This Addendum forms a part of the Contract Documents and modifies the original Bidding Documents dated May 10, 2019, as noted below. Acknowledge receipt of the Addendum in the space provided on the Bid Form. Failure to do so may subject the Bidder to disqualification.

Project: Facility Upgrades at 19 Union Street
WBRC Project Number: 4277.00
Meeting Date/Time: May 23, 2019 - 10:00am
Meeting Location: 19 Union Street, Augusta, Maine

**FACILITY UPGRADES AT
19 UNION STREET**
BUREAU OF REAL ESTATE
MANAGEMENT

**PROJECT:
BASEMENT FLOOR PLAN**

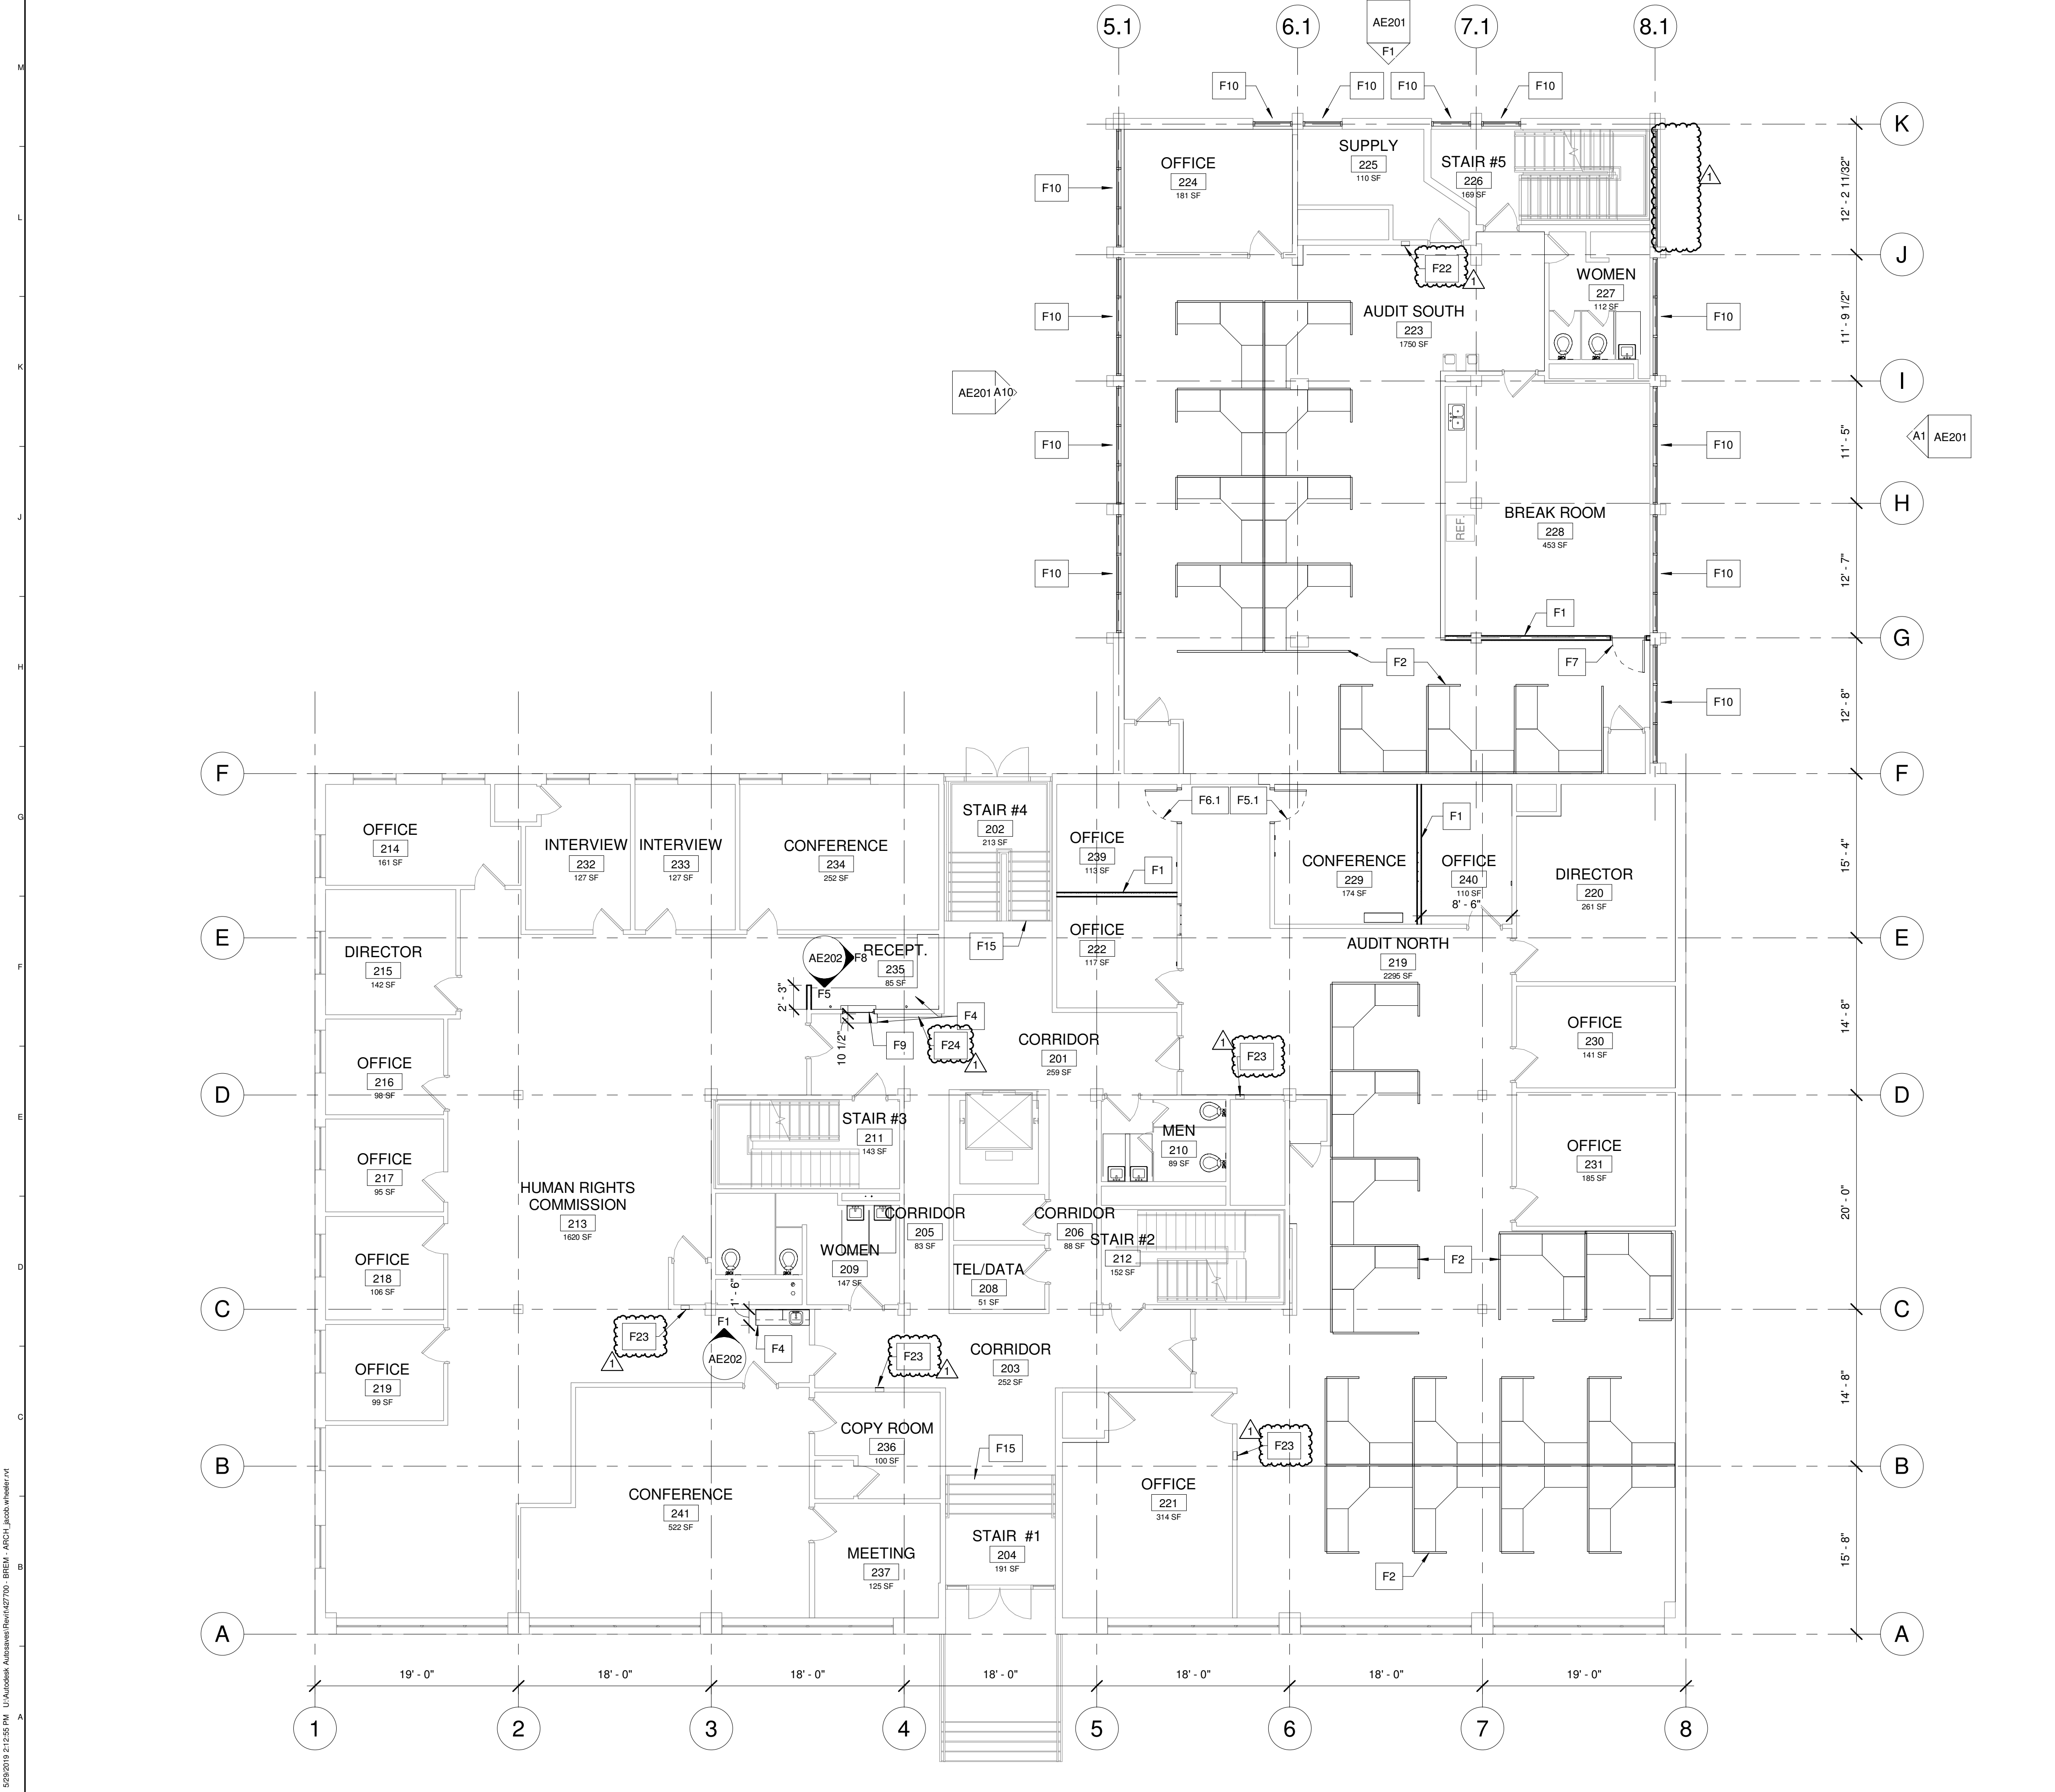
5. AE100-AE102 – Floor Plan Keynotes are not all found on the drawings. Can you define which are not used on each page?
Answer: Not all apply to each sheet. This has been clarified in Addendum #1 with reissuance of sheets AE100, AE101, AE102.

6. AE101 – Shows new double doors on Stair #5 with no plan floor keynotes detail, is this an error?
Answer: Disregard door shown on AE101. See revised sheet AE100.

10. Sheet AE100, Basement Floor Plan, DELETE and REPLACE with attached sheet.
11. Sheet AE101, First Floor Plan, DELETE and REPLACE with attached sheet.
12. Sheet AE102, Second Floor Plan, DELETE and REPLACE with attached sheet.
13. Sheet EL100, Basement Lighting Plan, DELETE and REPLACE with attached sheet.
